HISTORIC AND DESIGN REVIEW COMMISSION

May 06, 2015

Agenda Item No: 34

HDRC CASE NO: 2015-177
ADDRESS: 849 E COMMERCE ST
LEGAL DESCRIPTION: NCB 1010 BLK 2 LOT 26 RIVERCENTER SUBD
ZONING: D RIO-3
CITY COUNCIL DIST.: 1
APPLICANT: Christian Oviatt
OWNER: New Rivercenter Mall II, L.P.
TYPE OF WORK: Signage
REQUEST:

LIME CLOCK

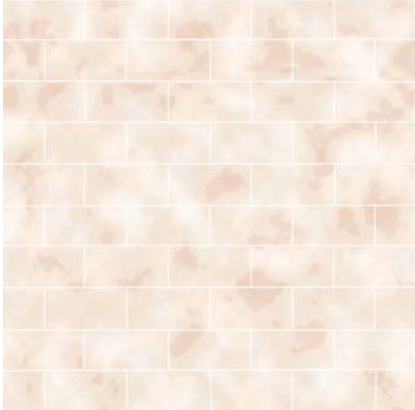
- d. The applicant has proposed to construct a covered patio extension in the area of the existing planter at the river level that is to include an awning with themed railing. The applicant has proposed for the canopy to include a teak wood finish, a teak wood wainscoting, metal bamboo style railing, a standing seam metal roof, string lights and a lime clock. The applicant’s proposed materials as well as lighting proposal are consistent with the UDC Section 35-674(d) regarding materials and finishes, and UDC Section 35-674(g) regarding awnings, canopies and arcades.

- i. That the proposed lime clock that is to be mounted at the river level on the proposed awning addition be indirectly lit and be constructed of aluminum.

VERTICALLY ORIENTED, INTERNALLY ILLUMINATED
BLADE SIGN MOUNTED TO FRONT OF COLUMN
PERPENDICULAR TO COMMERCE STREET.

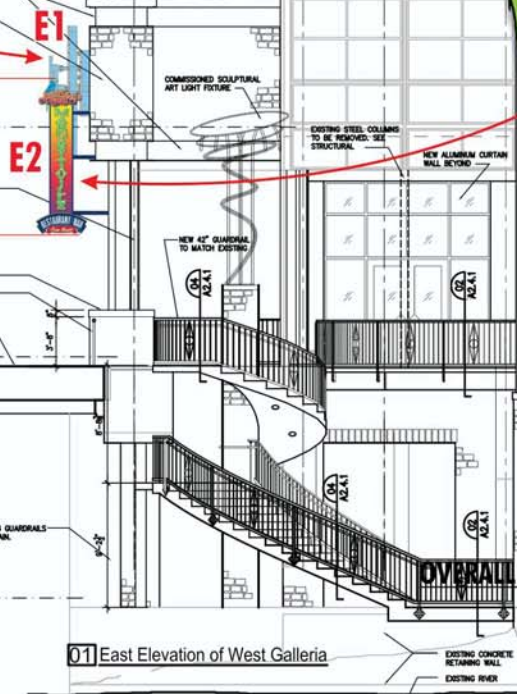
- c. The applicant has proposed to install a vertically oriented internally illuminated blade sign displaying “Jimmy Buffet’s Margaritaville”, “Restaurant + Bar” and “Live Music” and will total twenty-five (25) square feet. The proposed blade sign will be mounted to a column perpendicular to E Commerce as well as a horizontally oriented internally illuminated channel letter sign displaying “Jimmy Buffet’s Margaritaville” that is to include the complete branding logo featuring a blue parrot, palm trees, waves and a setting sun and will total twenty-five (25) square feet. According to the UDC Section 35-678(c)(1), the size, scale, height, color and location of signs shall be harmonious with, and properly related to, the overall character of the district and structure. At this location, staff finds the applicant’s proposal of two internally illuminated channel letter signs appropriate given the existence of other similar signs and the non-historic status of the structure to which they will be mounted.

Staff recommends approval of items #2 through #4 based on findings c and d with the following stipulations:

INTERNALLY ILLUMINATED CHANNEL LETTERS
MOUNTED TO FACE OF STONE BANDING, FACING
THE LAGOON.

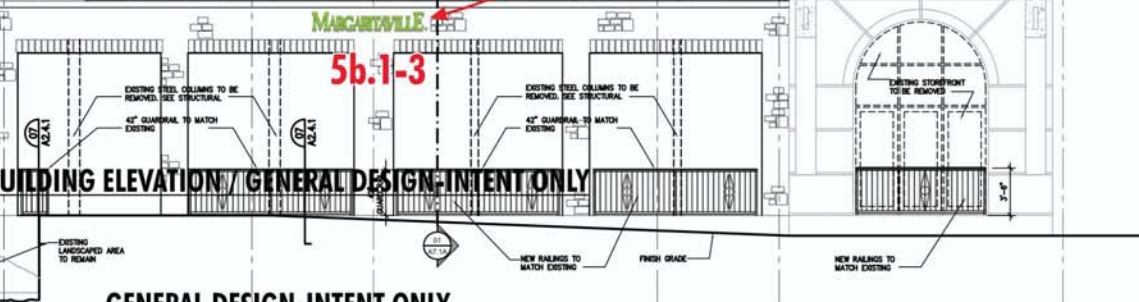
- b. The applicant has proposed to install a horizontally oriented internally illuminated channel letter cabinet sign displaying “Margaritaville” totaling eight (8) square feet at the river level. The sign will be mounted to the limestone façade of the mall. According to the UDC Section 35-678(c)(1), the size, scale, height, color and location of signs shall be harmonious with, and properly related to, the overall character of the district and structure. Staff finds that a reverse channel letter sign with halo type lighting would be more appropriate and consistent with other river level signage.

Staff does not recommend approval of item #1 based on finding b. Staff recommends that the applicant consider an aluminum, reverse channel letter halo lit sign that would be more appropriate at the river level than the proposed internally lit channel letter sign.
